UNITED STATES  
NUCLEAR REGULATORY COMMISSION  
WASHINGTON, D. C. 20555

DCD-016

SUBJECT: SUMMARY OF MEETING WITH WESTINGHOUSE OWNERS GROUP (WOG) ON JULY 30, 1982, CONCERNING THE PRESSURIZED THERMAL SHOCK (PTS) ISSUE

NRC CRACK ARREST MODEL

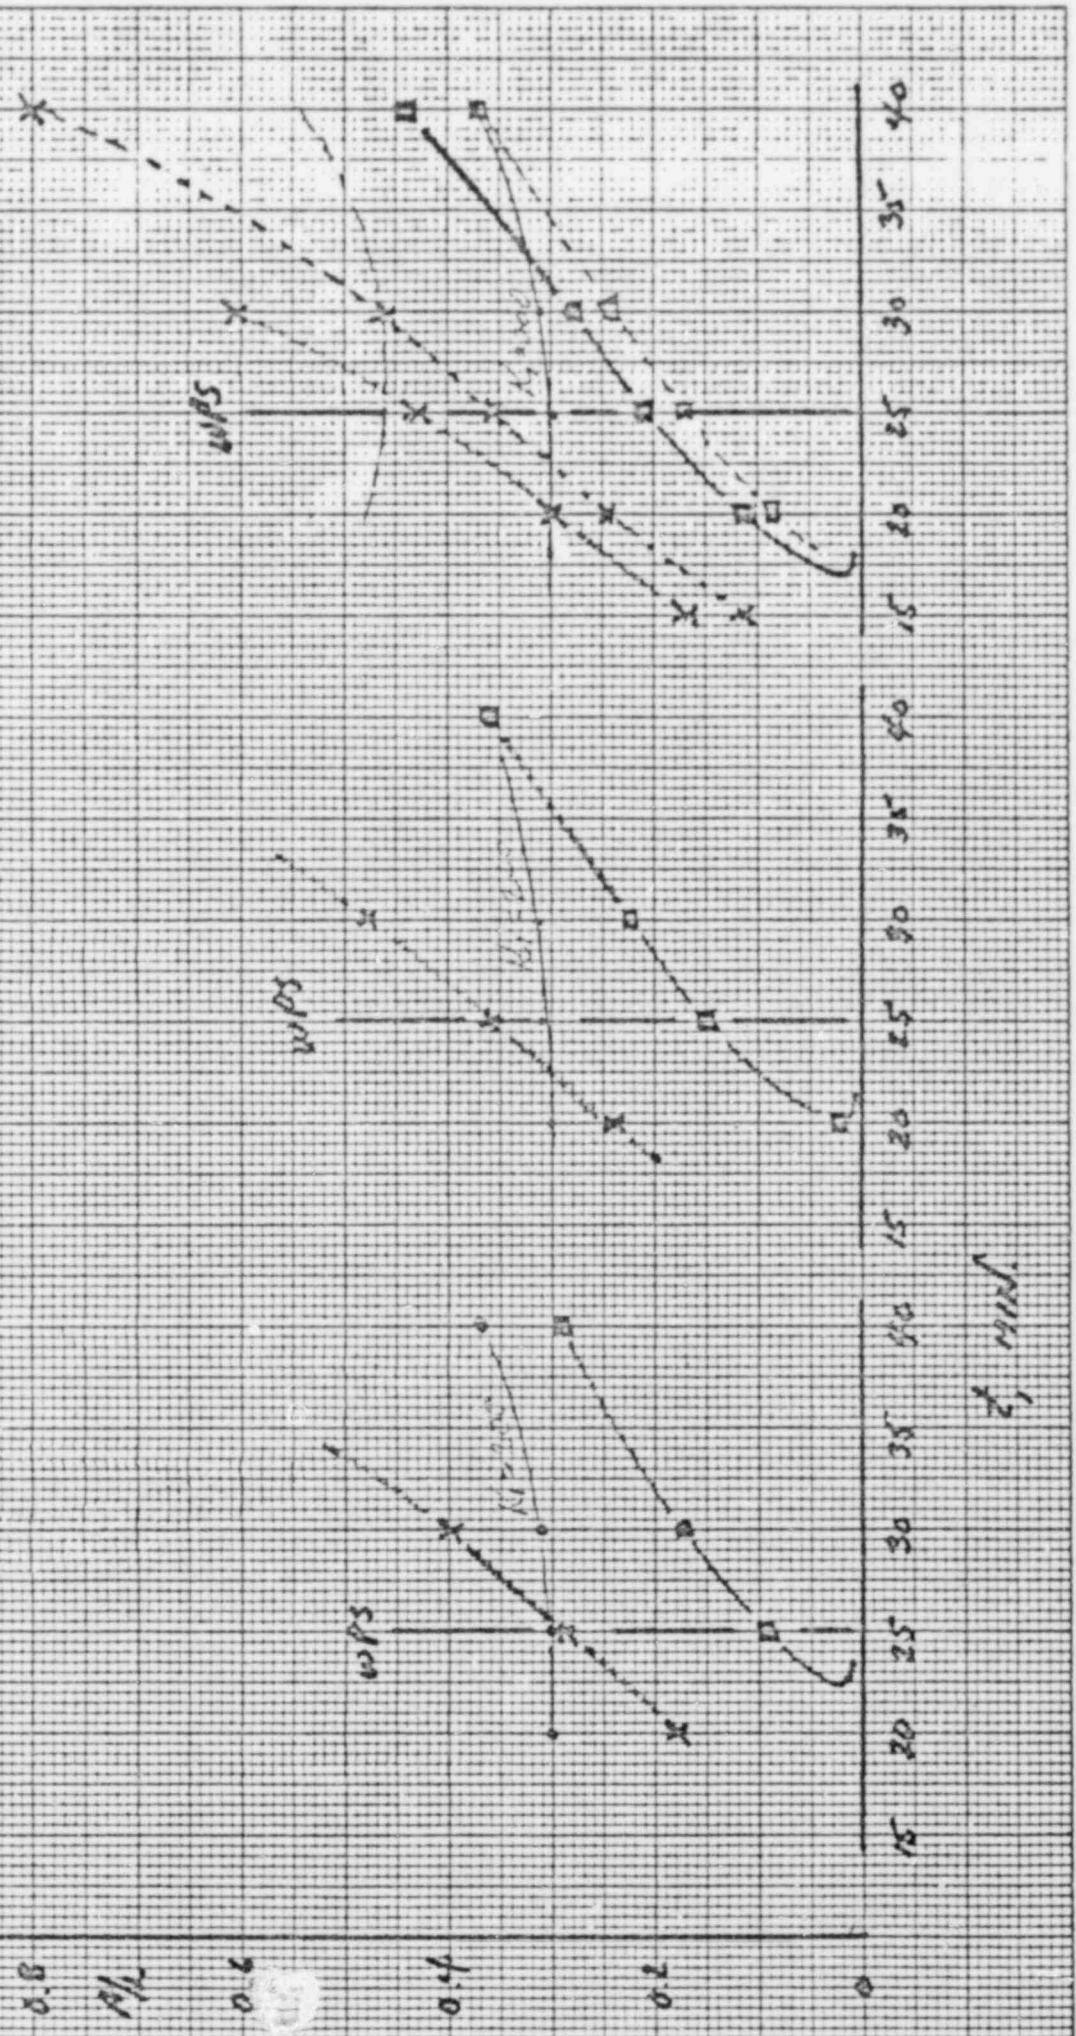
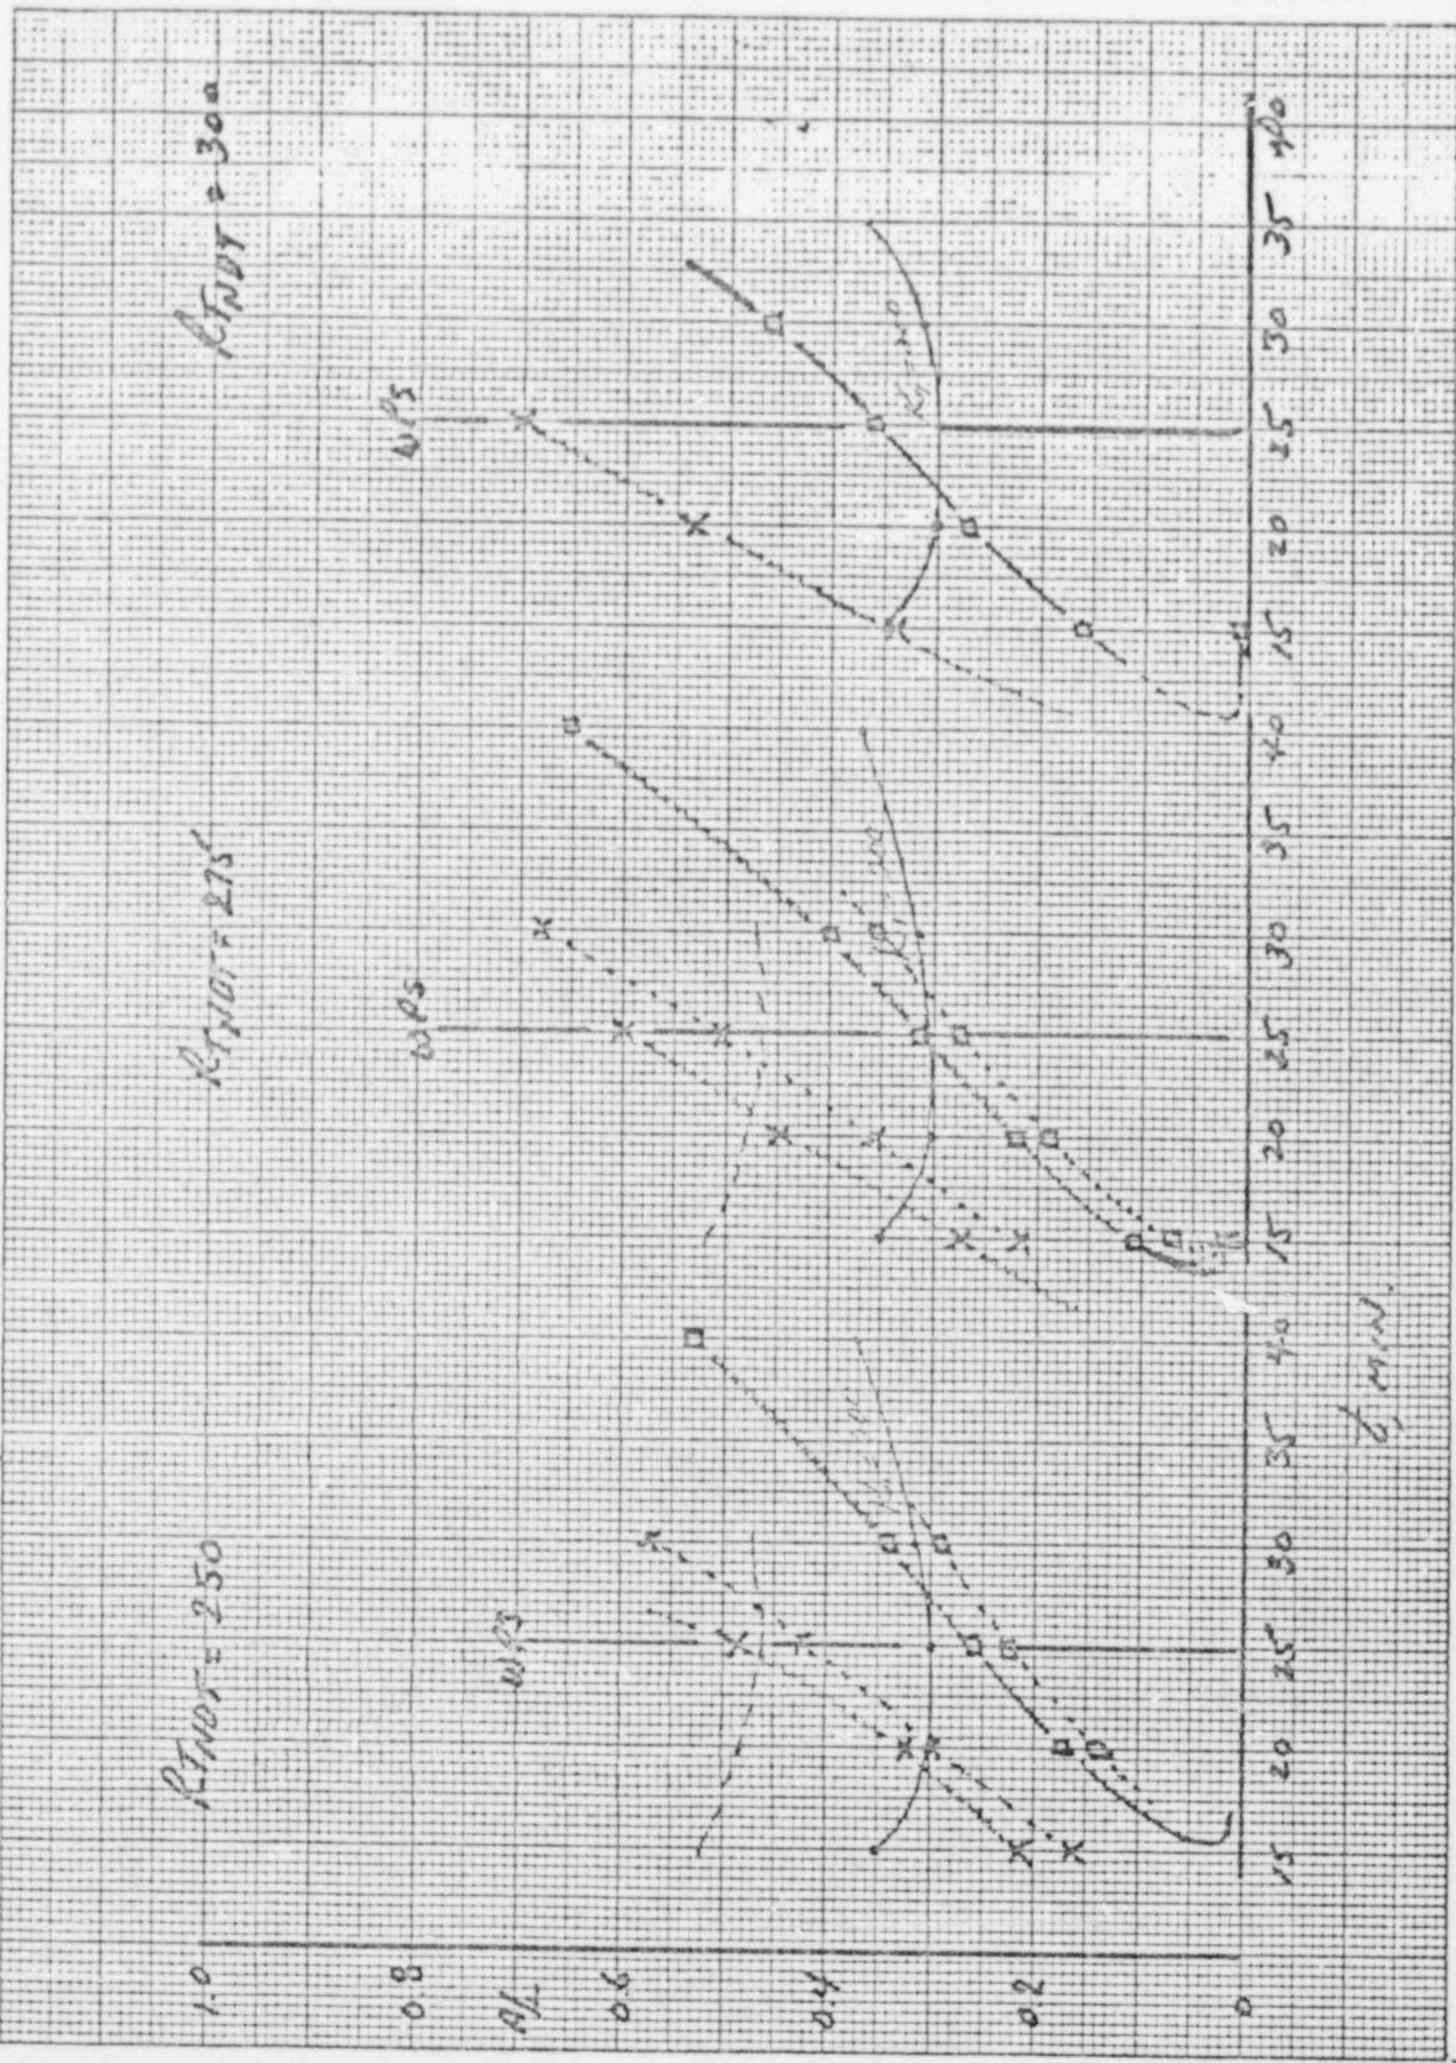
FOR A GIVEN THERMAL TRANSIENT, AND A  
GIVEN  $R_{T,0}$  AT THE VESSEL INNER  
RADIUS, MAXIMUM PRESSURE IS DETERMINED  
WHEN CRACK ARREST OCCURS AT  $200 \text{ ksi/in.}$   
AT THE TIME WARM PRESTRESSING OCCURS  
(POINT "A" IN THE ABOVE FIGURE)
